PARACHUTES AUSTRALIA

SERVICE BULLETIN No PA SB98/01

SUBJECT: '94 TALON MAIN CONTAINER CLOSING LOOP POSITION

Figure 1

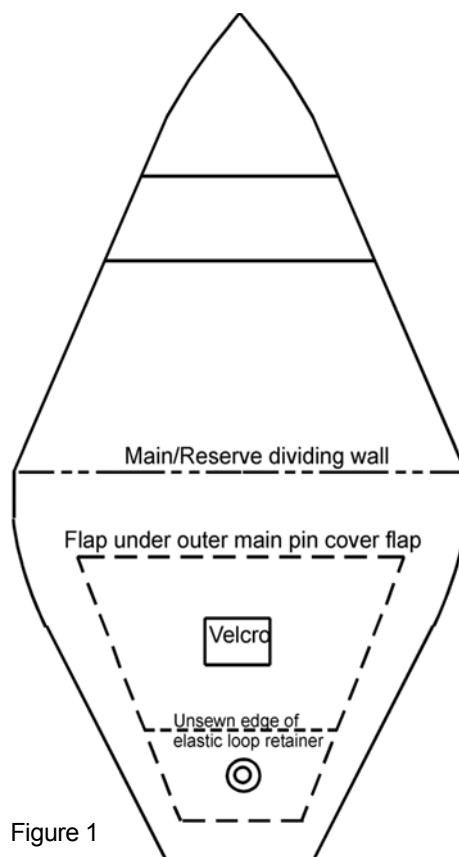
MANUFACTURER ADVISORY: PA strongly recommends that the loop position be changed from the main/reserve dividing wall to the new position. A 40mm wide elastic retainer is sewn to the under side of the flap to hold the loop after deployment. The loop retainer is placed over the "0" grommet and sewn on 3 sides into the binding tape leaving one side open where indicated for changing the closing loop .

Remove the previous loop retainer after unpicking the first row of stitching that attaches it onto the main/reserve dividing wall and heat seal to prevent fraying. This may be completed by an APF Packer A or foreign equivalent.

See diagram 1. of the new loop positions of the closing loop and elastic loop retainer.
